**RE: Epiq Estate Lennox Head (Pacific Pines Estate) – Response to Submissions and Additional Information (MP 07\_0026 MOD 7)**

## **Attachment 1: Detailed BCD Comments – Epiq Estate Lennox Head – Response to Submissions (MP 07\_0026 MOD 7)**

**Figure 1. Typical Section 20m Road Reserve (Source: Attachment 4. Engineering Services Report in the EA for MOD 7. Civil Works Longitudinal Section MC01 Drawing No 14351-S5-DA-C1-11 Newton Denny Chapelle).**

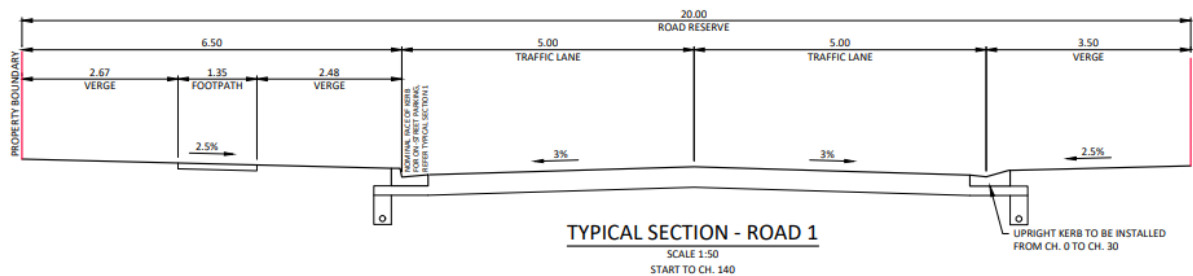
The argument that the proposed track will have less nutrient and pollutant levels than a perimeter road does not acknowledge that a road reserve would incorporate grassed swale edges on either side as shown below in a typical section in Figure 1.

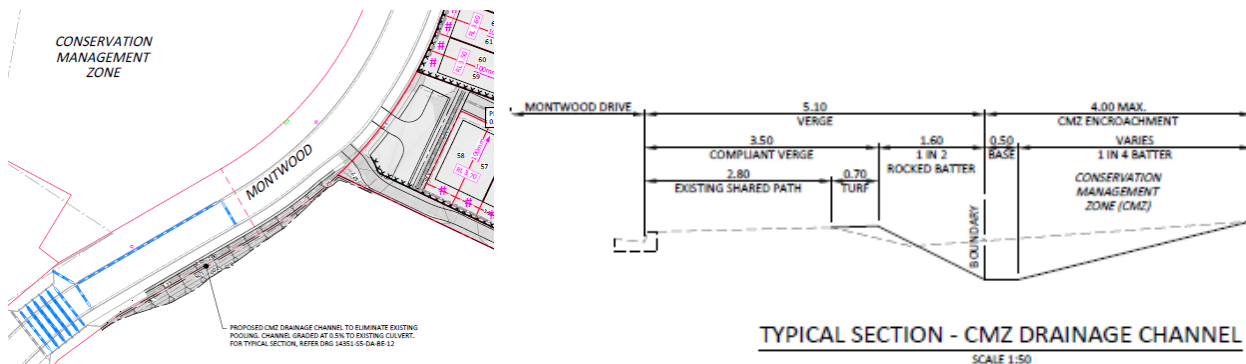
The RtS contains an amended Civil Works and Bulk Earthworks Plans. A drainage channel is now described that encroaches into the CMZ by 4m as shown in Drawing No. 14351-S5-DA-BE-12. The RtS states the additional drain is proposed to address the council's concerns regarding the drainage of low-lying areas of the CMZ and the location and configuration of this drain has been developed in consultation with the Ballina Shire Council. However, it appears the encroachment would not be consistent with the conditions of consent that no construction works are to be undertaken within the CMZ. We question whether this can be approved given the impact on the CMZ.

- b. the modification involves a drainage channel that encroaches into the CMZ which is also not consistent with the EMP.
2. Pending resolution of the issues raised in our recommendation 1 above, the BCD recommends the proponent be required to demonstrate that the wetland community vegetation in the Conservation Management Zone (CMZ) will be sufficiently buffered from the impacts of the development by the proposed arrangement. This would include:

**Figure 2. Typical section CMZ Access Track as described in RtS Attachment 2 (on left) and Attachment 1 (on right).**

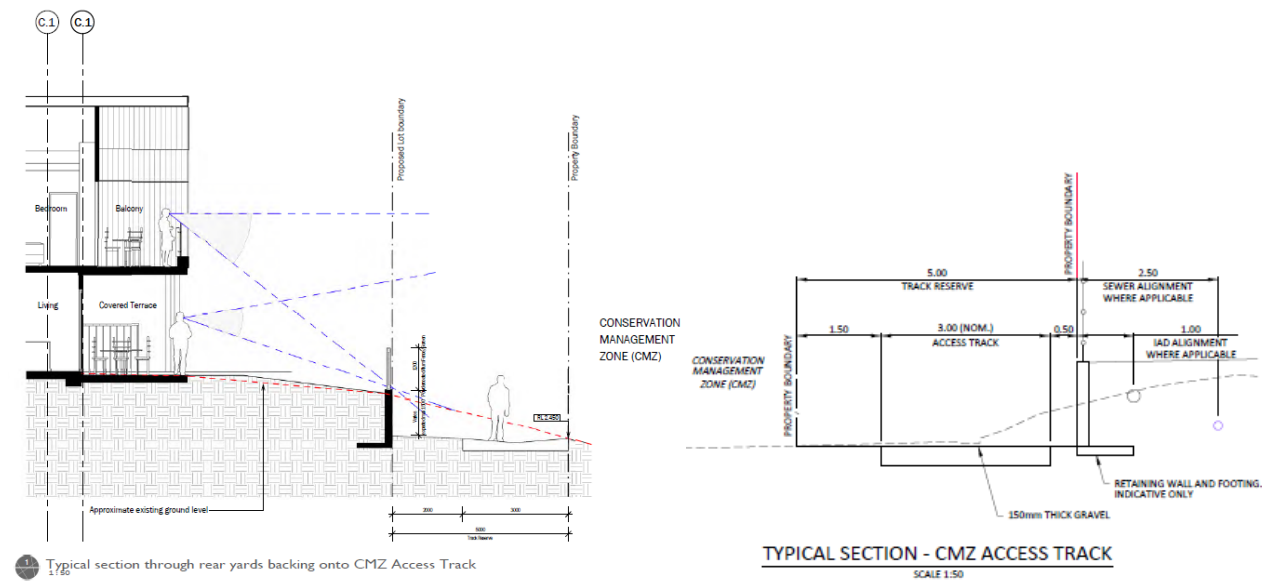
However, there are other aspects of this arrangement that are not satisfactory. For example, there are discrepancies in the design of the access track and vegetated strip in the RtS as shown in the typical cross sections in Figure 2 below. One shows the planted strip adjacent to the retaining wall and the other adjacent to the CMZ. There are no details of how this area will be planted.

- c. Resolution of the inconsistencies in the access track design as shown in the typical sections (Attachments 1 and 2).
  - d. Detail of the landscape design and maintenance requirements for the vegetated strip to meet the bushfire asset protection requirements.

**Figure 3. Backyards and access track within the 10m asset protection zone.**

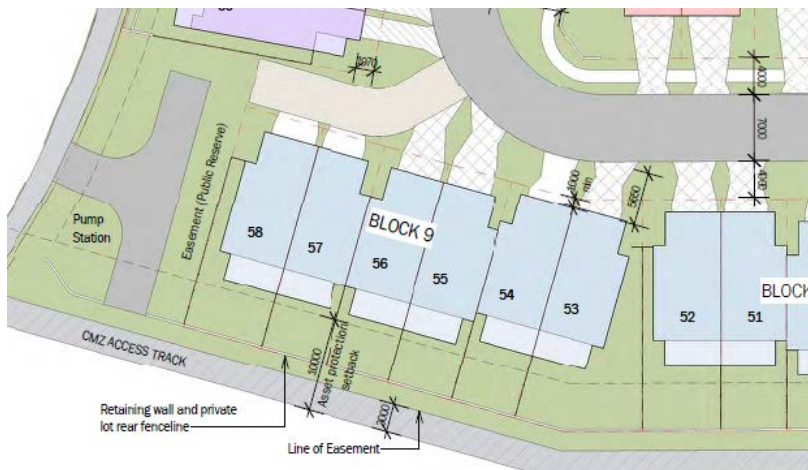
The backyards of the residential lots and the access track and vegetation zone are all within the required 10m-wide asset protection zone (APZ) (see Figure 3). Such a planted buffer will have to comply with the bushfire protection measures and for example contain no overlapping tree canopies or other continuous vegetation. This appears to conflict with the Landscape Concept Design Report (LCDR) which states that a planted buffer will be provided abutting the conservation zone and be comprised of trees and understorey. The LCDR also contains images such as the one below which would not be possible in an APZ. It is recommended these discrepancies be considered.
